Meeting Agenda Planning Commission

Wednesday, May 13, 2020

**TECHNICAL REVIEW PLAT REQUIREMENTS
REGULAR PLANNING COMMISSION MEETING
MAY 13, 2020**

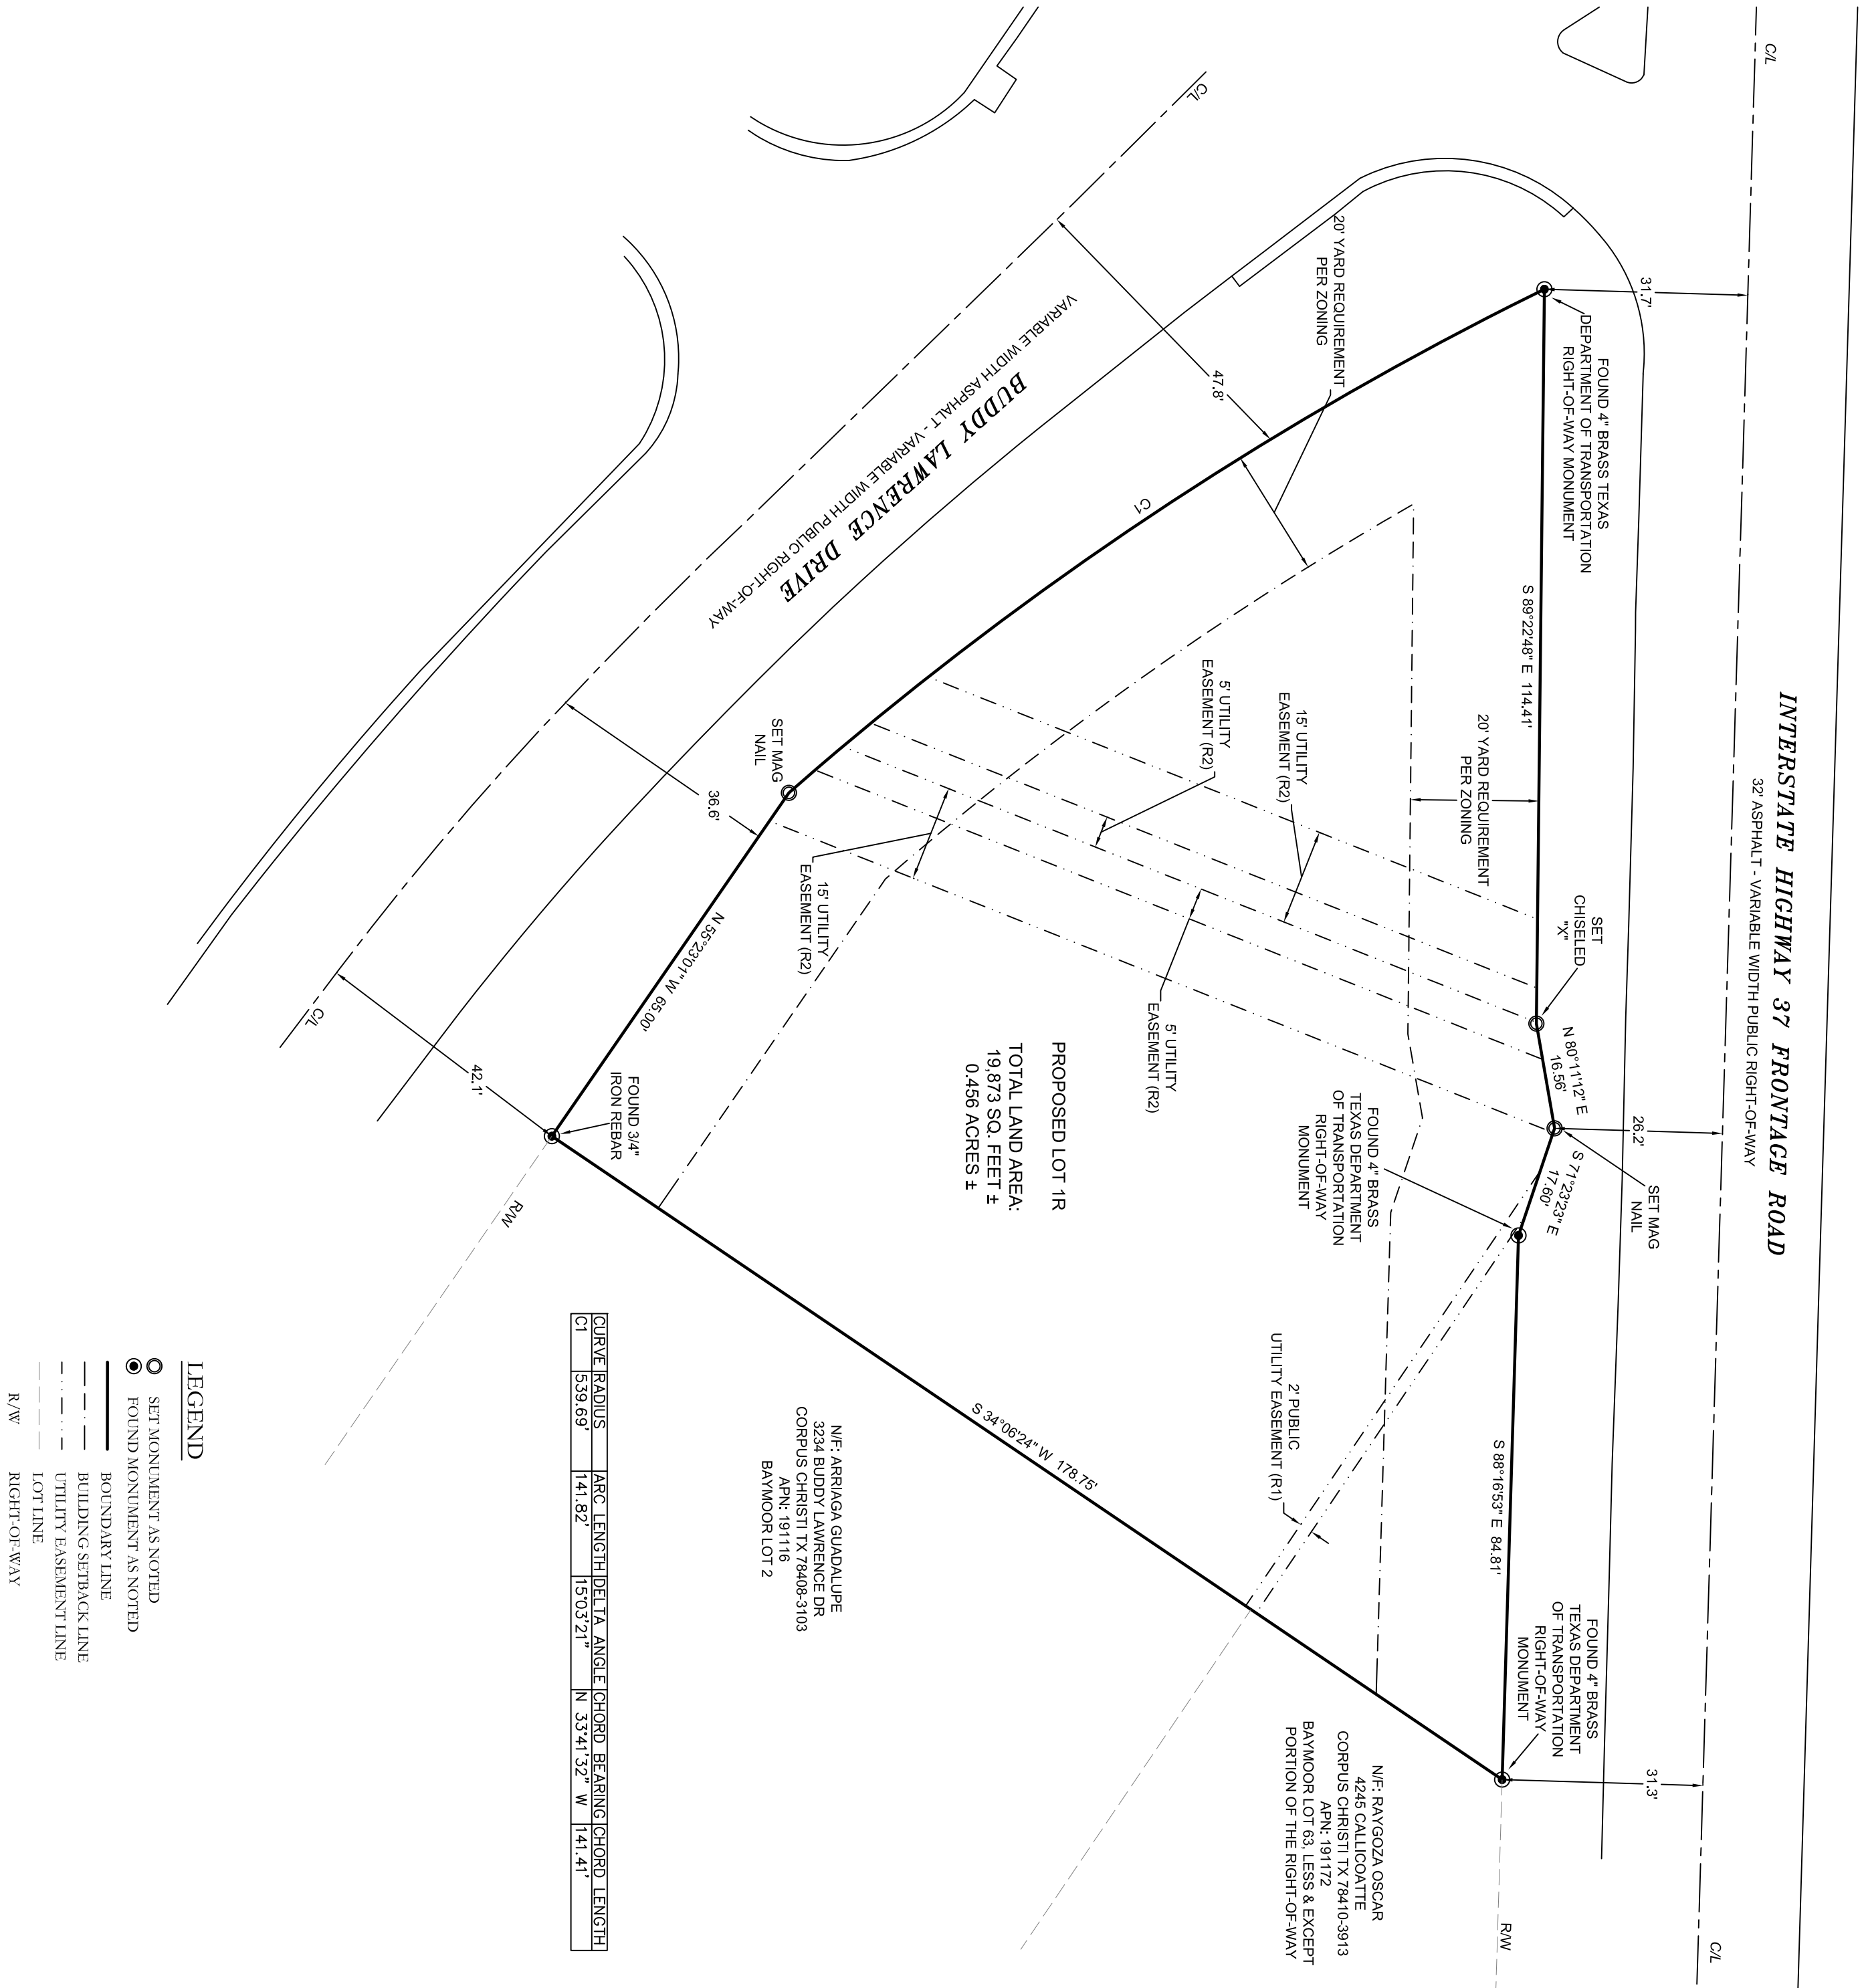
GIS						
No.	Sheet	Comment	Applicant Response	Staff Resolution	Applicant Response	Staff Resolution
1	Plat	The plat closes within acceptable engineering standards.	Acknowledged	Resolved		
2	Plat	Label the right of way widths and centerline dimensions for all streets and alleys shown on the plat. In the event the right of way varies, provide and label the dimensions at a given point.	Revised. Unable to determine right of way widths, it is not specified in any record documents or prior surveys	Resolved		
3	Plat	Proposed lot number on platted area should match plat title (Lot *1R)	Revised	Resolved

4	Plat	All inside street corner intersections require a radius of a minimum of 10' on local residential streets, 15' to 20' on collector/commercial/industrial streets and 20' to 50' on arterials. The radius may vary depending on the circumstances.	Acknowledged	Resolved		
5	Plat	Highway 37 is an Interstate Highway. Please revise labeling on platted area as well as location map.	Revised	Not Resolved. Platted area and location map still reads "STATE HIGHWAY 37" and should read "INTERSTATE HIGHWAY 37"	Revised	Resolved

LAND DEVELOPMENT						
No.	Sheet	Comment	Applicant Response	Staff Resolution	Applicant Response	Staff Resolution
1	Plat	Update Development Services Engineer to Jalal Saleh, PE	Revised	Addressed.		
2	Plat	Update Planning Commission certificate as below at end of Land Development comments.	Revised	Addressed.		
3	Plat	The current lot lines can be remove along with the referenced legal description.	Revised	Addressed.		
4	Plat	Rename 20' Building Setback to 20' Yard Requirement.	Revised	Addressed.		
5	Plat	Provide Yard Requirement label for IH 37 frontage.	Revised	Addressed.		
6	Plat	Update lot label within platted property with Lot number with acreage and square footage only.	Revised	Addressed.		
7	Plat	On Plat title, remove, "Subdivision Plat of"	Revised	Addressed.

8	Plat	For street half distance on Buddy Lawrence provide distances to center of street from the three points along property line.	Revised	Addressed.		
9	Plat	Metes and bounds description is not required for the plat and is not reviewed by our department. Verify there are no inconsistencies with plat and future Deed.	The plat will supersede all prior descriptions	Addressed.		
10	Plat	Remove the Zoning notes from plat as the zoning may change in future.	Revised	Addressed.		
11	Plat	Remove the County Health Department signature certificate as connection to Wastewater utilities is existing or will be connected.	Revised	Addressed.		
10	Plat	Provide ownership signature certificate as per State filing. Provide copy of state filing on ownership.	Revised	No addressed. Print name of owner on Owners certificate. Filings/documentation not provided.	Waiting for client to provide documentation and corrected owners name from MDC	No addressed. Print name of owner on Owners certificate. Filings/documentation not provided.

DEVELOPMENT SERVICES ENGINEERING						
No.	Sheet	Comment	Applicant Response	Staff Resolution	Applicant Response	Staff Resolution
1	Plat	Add the receiving Water note to the Plat (Inner Harbor Basin)).	Revised	Addressed.		
2	Plat	Verify the need for the UE's on site; according to the City GIS system "no public utility easement exists on site".	Easements shown are from Baymoor Addition, Volume 4 Pg 42 & Baymoor Annex, Volume 22 Page 19	Addressed.

No.	Sheet	Comment	Applicant Response	Staff Resolution	Applicant Response	Staff Resolution
1	Utility Plan	Purpose: To combine 2 commercial properties into 1. Note: Hydrant across street at Buddy Lawrence.	Acknowledged	Addressed.		
2	Utility Plan	Commercial Properties require a fire hydrant flow of 1,500 GPM with 20 psi residual with a fire hydrant every 300 feet.	Fire hydrant is located across the street at Buddy Lawrence; land is already developed	Addressed.		
3	Utility Plan	Note: Hose lay from hydrant will not cross major street artery.	Acknowledged	Addressed.
